STATE OF MAINE
DEPARTMENT OF ENVIRONMENTAL PROTECTION
BUREAU OF REMEDIATION AND WASTE MANAGEMENT
DIVISION OF TECHNICAL SERVICES
M E M O R A N D U M

TO: Linda Butler, Project Manager
FROM: Gail Lipfert, PhD, C.G. # GE506 Hydrogeologist
DATE: April 15, 2020
RE: Phase 14 Solid Waste Permit Application, Volume III, Crossroads Landfill, Waste Management Disposal Services of Maine (WMDSM), Norridgewock, Maine
CC: Chris Evans, C.G., Hydrogeology Unit supervisor, Kathy Tarbuck, P.E., Project Engineer

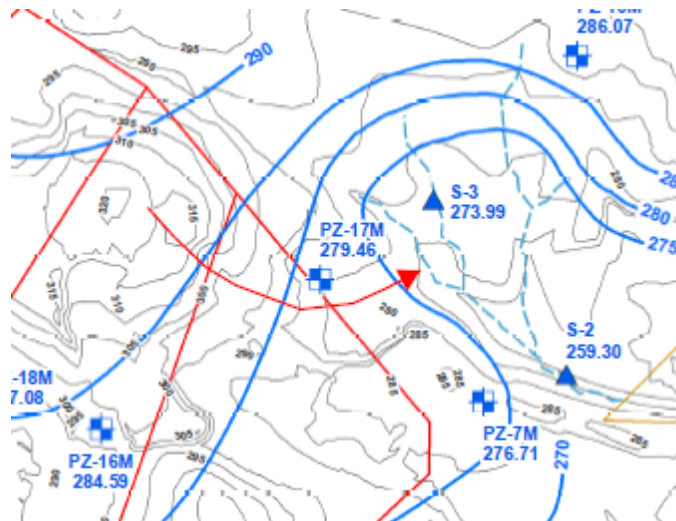
- a. Please clarify the phrase “from northeast to southwest/southeast”. Northeast to southwest is an understandable direction, but northeast to southeast is not. We suspect that this phrase is intended to indicate that the direction is variable, that it is northeast to southwest and northwest to southeast.
- b. Fourth paragraph. MEDEP does not concur that “any phreatic groundwater that discharges to the streams in the area of S-2 originate north of S-2. Although examination of the potentiometric surfaces in Figures 12a and 12c shows that most of the flow comes from the north, there are some flow lines from northwest of S-2 that would pass through the footprint of Phase 14 on the way to S-2. See diagram below

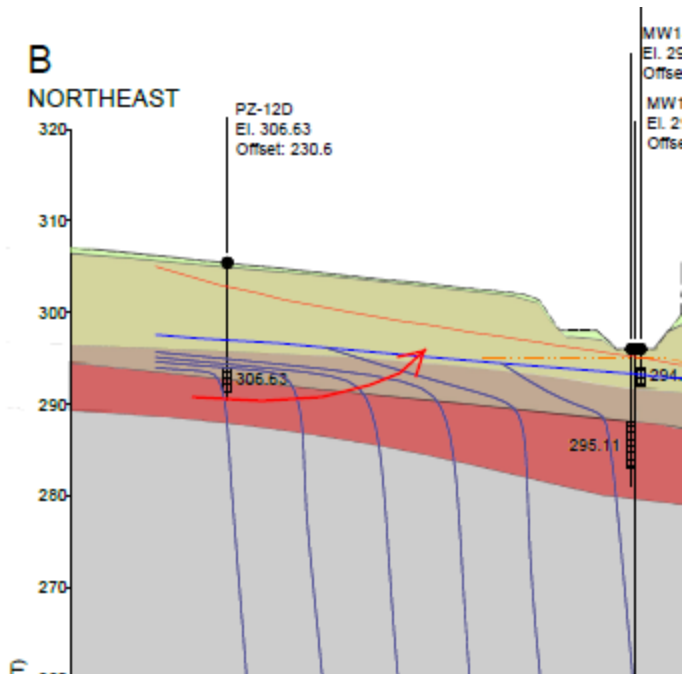
18. 5.3 Hydrostratigraphic Cross-Section. Water in the till to the NE appears to flow upward, discharging to the sand in an uphill area. Because there is no surface water body there, this representation is probably inaccurate. See diagram below. Please correct the cross-section.
